## DECISION OF THE PLANNING ADMINISTRATOR

**URBAN GROWTH AREA PRELIMINARY DECLARATION / CLASS 3 SITE PLAN  
REVIEW CASE NO.: UGA-SPR21-01**

**SUMMARY:** An Urban Growth Preliminary Declaration and Site Plan Review for the construction of an accessory structure proposed to serve the existing First Slavic Baptist Church.

SHEET:  
**A1.02**  
SITE PLAN

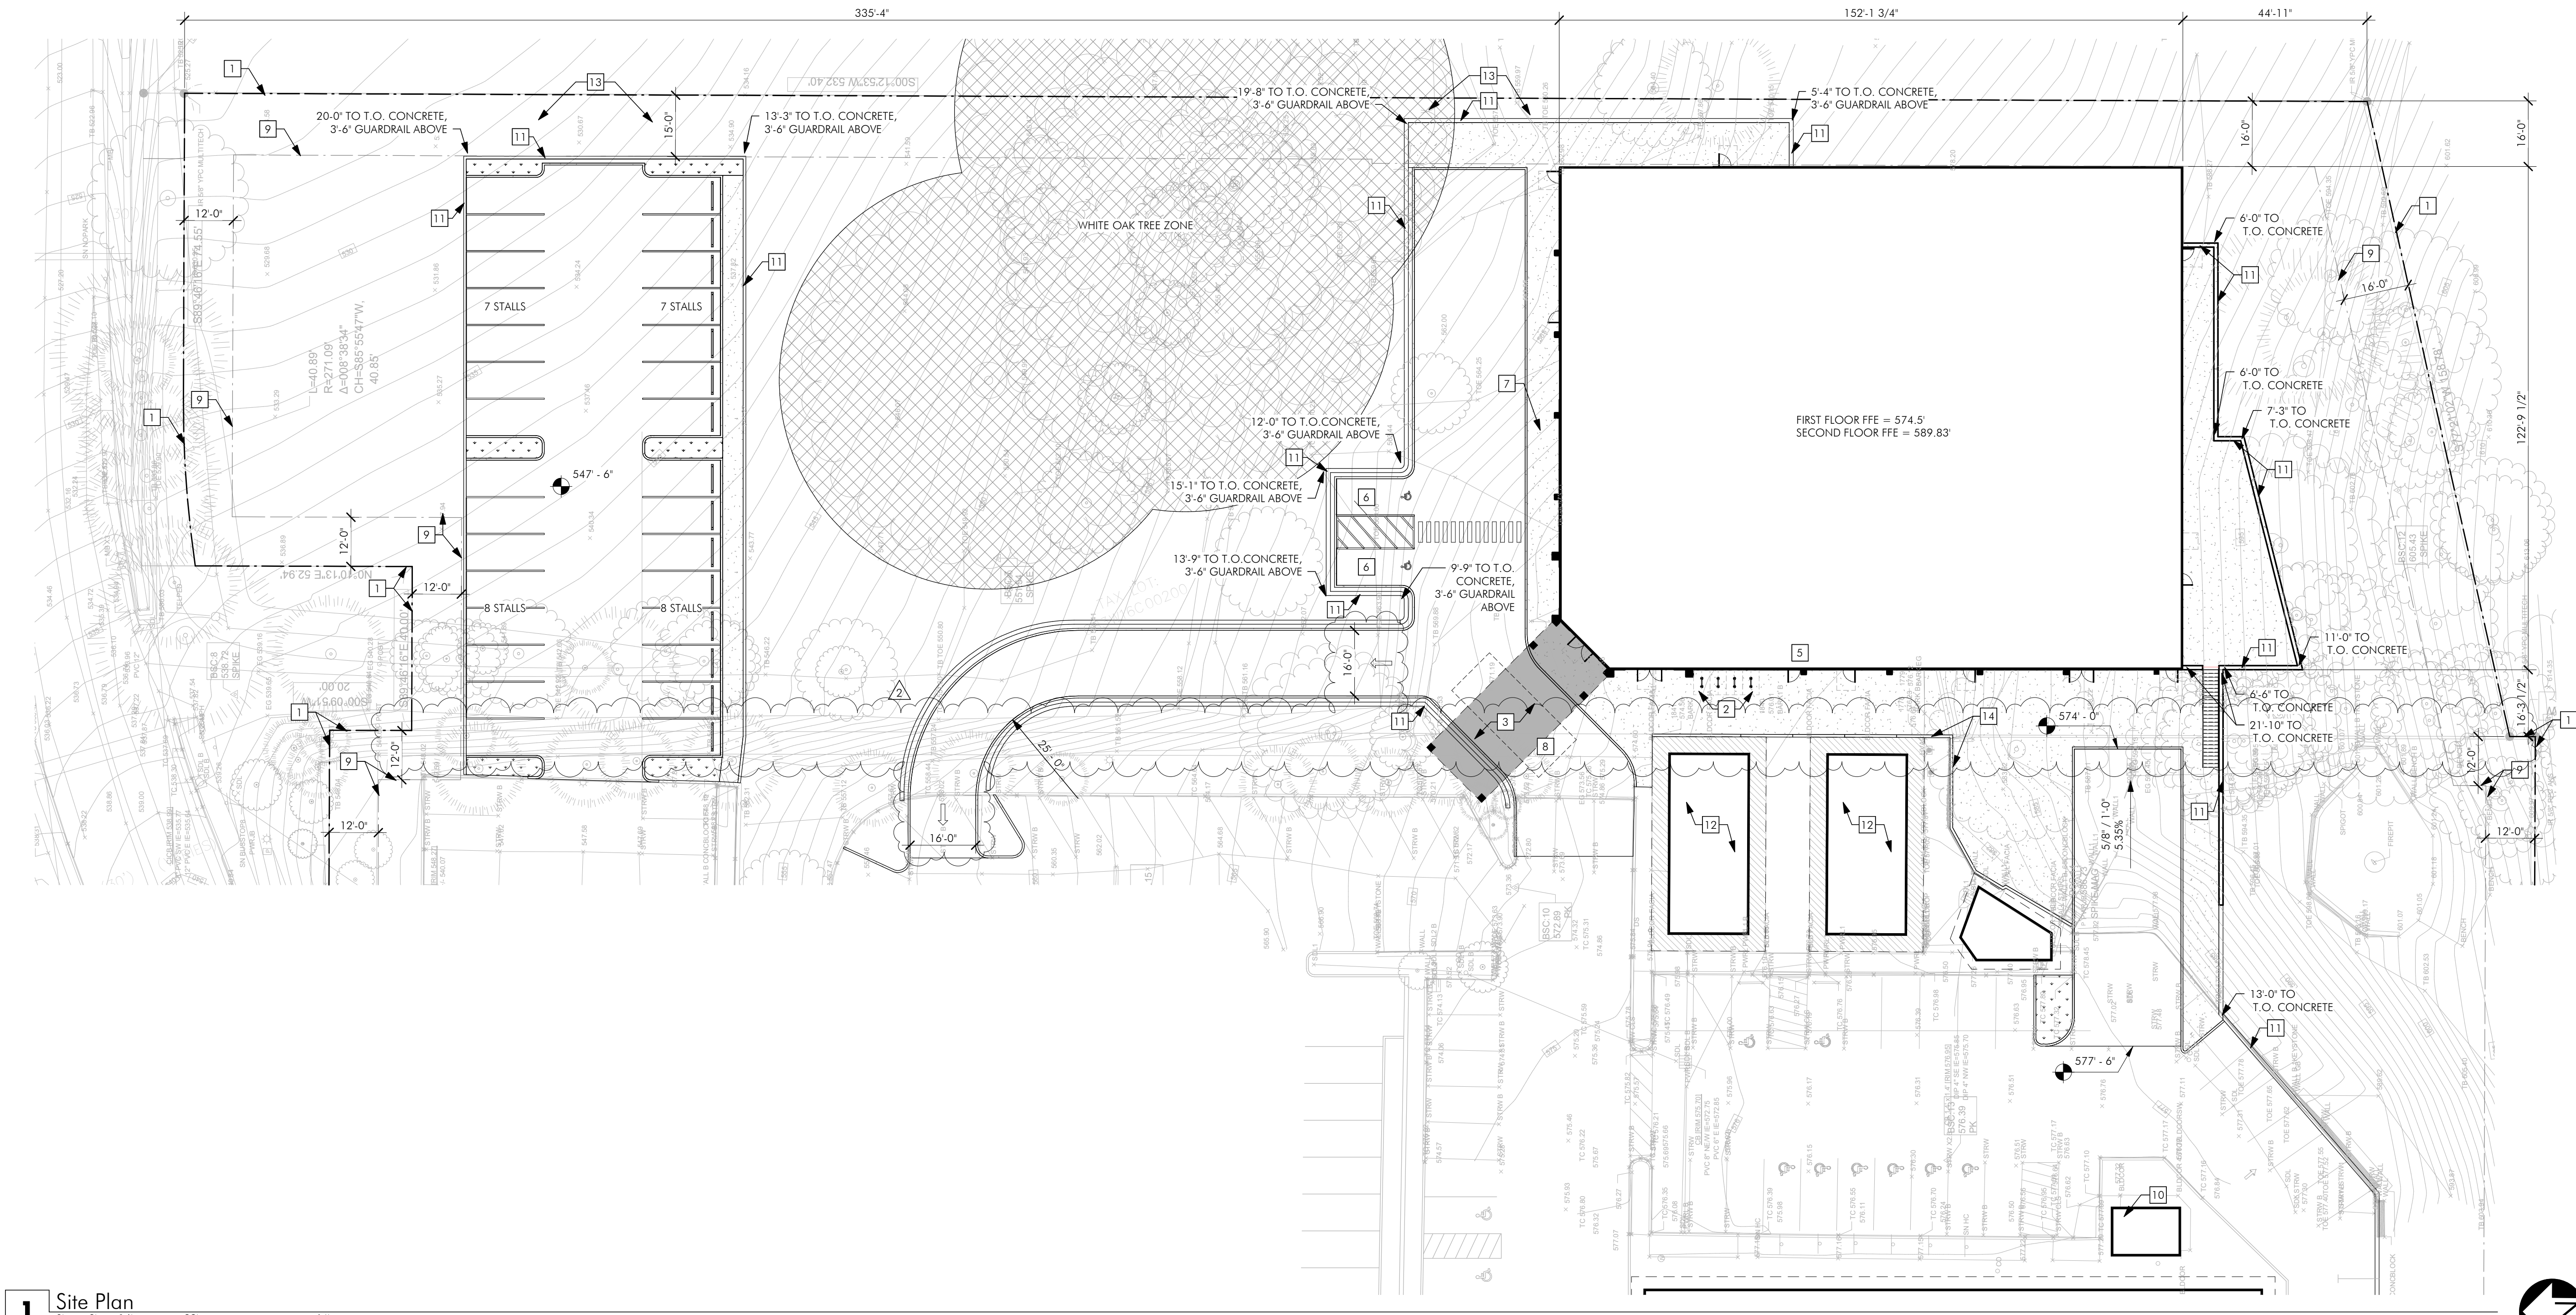
**Finding:** The applicant's development plans show that the areas which are not developed for buildings, structures, parking, loading, or driveways as landscaped, though the specific do not show the specifics of the landscaping type. In order to meet this standard, the following condition shall apply:

**Finding:** The applicant's plan does not currently show pedestrian connections between the buildings and Davis Rd S. In order to meet this standard, the following condition shall apply:

**Finding:** There is a transit stop located along the frontage of the development site. The site plan does not currently show a pedestrian connection near this stop. In order to meet this standard, the following condition shall apply:

**Finding:** There is one new driveway proposed to provide circular access from the vehicle use area adjacent to the new building to the existing parking lot. Table 806-7 requires a minimum of 12' for a one-way driveway, with 25 ft. inside radius of the curve. The proposed driveway meets this standard, however the Fire Department has indicated that additional access will be required to meet the Oregon Fire Code in the proposed orientation. A turn-around located within 150 feet or wider driveway at least 20' in width are options which would provide adequate access for the Fire Department. In order to ensure proper access, the following condition shall apply:

**Fining:** The applicant has provided a preliminary plan which shows which trees are proposed to be removed, there are currently two trees (12" oak and 13" oak) proposed for removal within a required setback. Two new trees for each tree removed are required to be planted. In order to ensure compliance with this section, the following condition shall apply:

**Condition 6:** The applicant shall provide Fire Department access and water supply as required per the Oregon Fire Code.

**Condition 7:** In addition to the landscaping requirements of SRC 807, a minimum of two shade or evergreen trees with a minimum 1.5 inch caliper shall be planted for each tree removed within the required setback.
